DECISION OF THE PLANNING COMMISSION

**CLASS 3 DESIGN REVIEW, CLASS 3 SITE PLAN REVIEW, CLASS 2 ZONING
ADJUSTMENT, CLASS 2 DRIVEWAY APPROACH PERMIT CASE NO. DR-SPR-ADJ-
DAP19-11**

SUMMARY: Proposed development of a new 246-unit multiple-family residential apartment complex.

LOCATION: 2575 Center St NE

**EXISTING
 CONDITIONS
 PLAN**

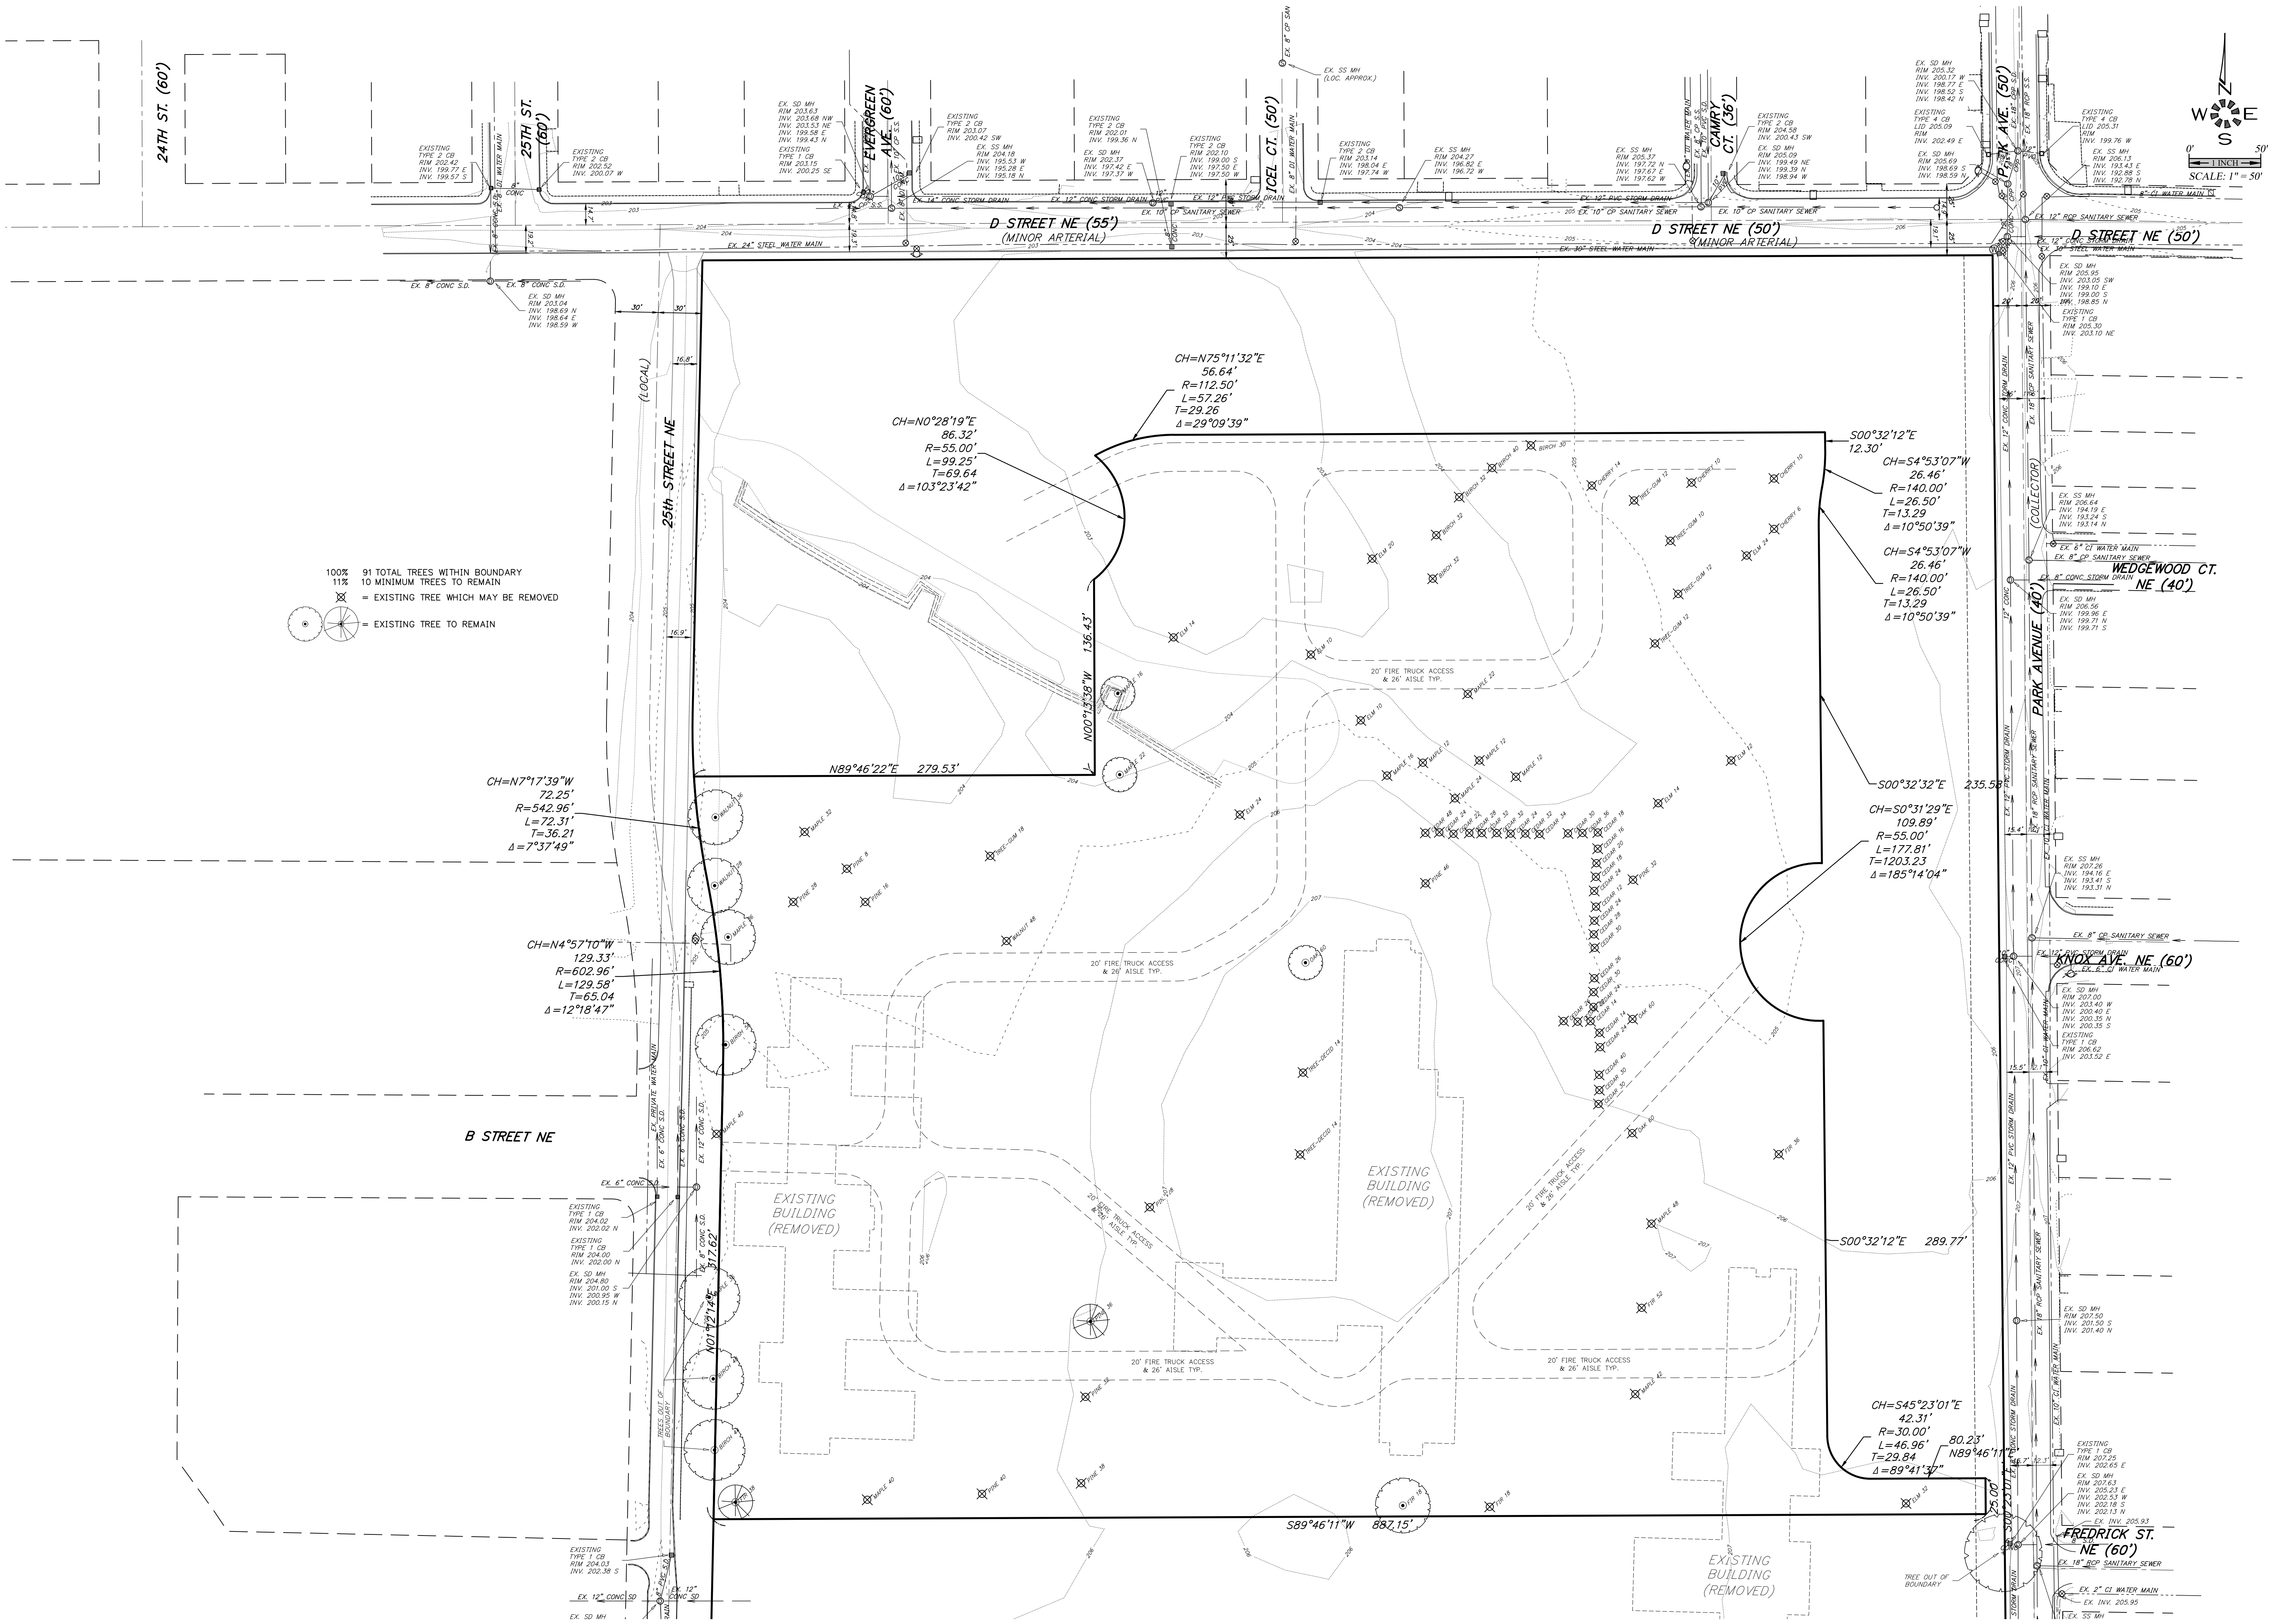
Finding: The existing conditions plan provided by the applicant indicates that there are 91 existing trees on the subject property. Ten of the existing trees will be preserved and incorporated into the site landscaping, 81 trees (89 percent) are proposed for removal. The applicant is required to provide additional plantings pursuant to SRC Chapter 807.

Finding: The existing conditions plan indicates that there are 91 trees on the subject property, and that 81 of the trees (89 percent) will be removed. For each tree removed beyond 68 (75 percent), a minimum of two replacement trees shall be incorporated into the landscape design. A minimum of 26 trees are required to be replanted for the 13 trees proposed to be removed beyond 75 percent, replacement trees are in addition to the tree planting requirements of Chapters 702 and 807.

Condition 3: A minimum of 26 trees are required to be replanted for the 13 trees proposed to be removed beyond 75 percent. These replacement trees are in addition to the tree planting requirements of Chapters 702 and 807.
